UNITED STATES PATENT AND TRADEMARK OFFICE

Office Action Summary

10/693,981

TAMURA, MASASHIGE

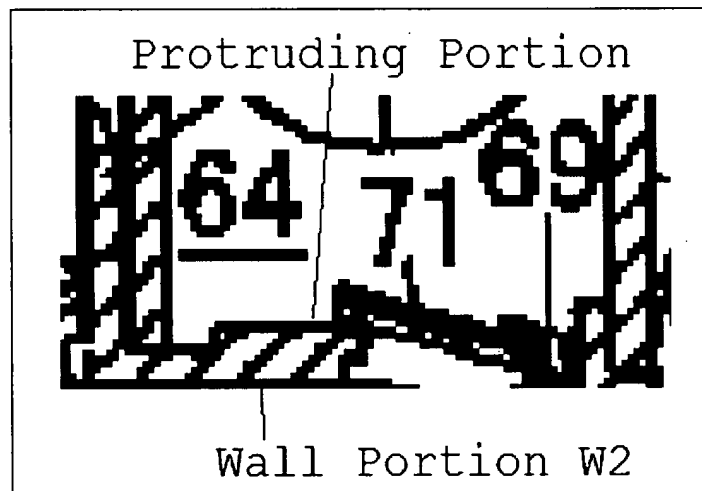
Upper wall (W2) is a wall portion provided in the second chamber on a side on which the opening and closing member (71) is opened. A portion of developing device (Dm) from figure 27 is shown below, which shows that wall portion (W2) has a protruding portion protruding toward an inside of the second chamber (64).

Regarding claim 2, the wall portion (W2) is provided between the opening (74) and the carrying member (R2) so as to narrow a developer containing space in the second chamber (64).

Regarding claim 3, the opening (67a) is located above the wall portion (W2) when the excess developer can be discharged through the opening, for example in the case of Dm in figure 27.

Regarding claim 4, the second chamber (64) has a substantially U-shaped cross section, and the wall portion is provided so as to protrude from a straight portion of the U-shape toward the carrying member side.

Applicant submits that Notani et al. do not teach a protruding portion of a wall portion that protrudes toward an inside of the second chamber. However, as indicated in the figure above the wall portion (W2) of Notani et al. is clearly sectioned, having one portion protruding toward an inside of the second chamber.
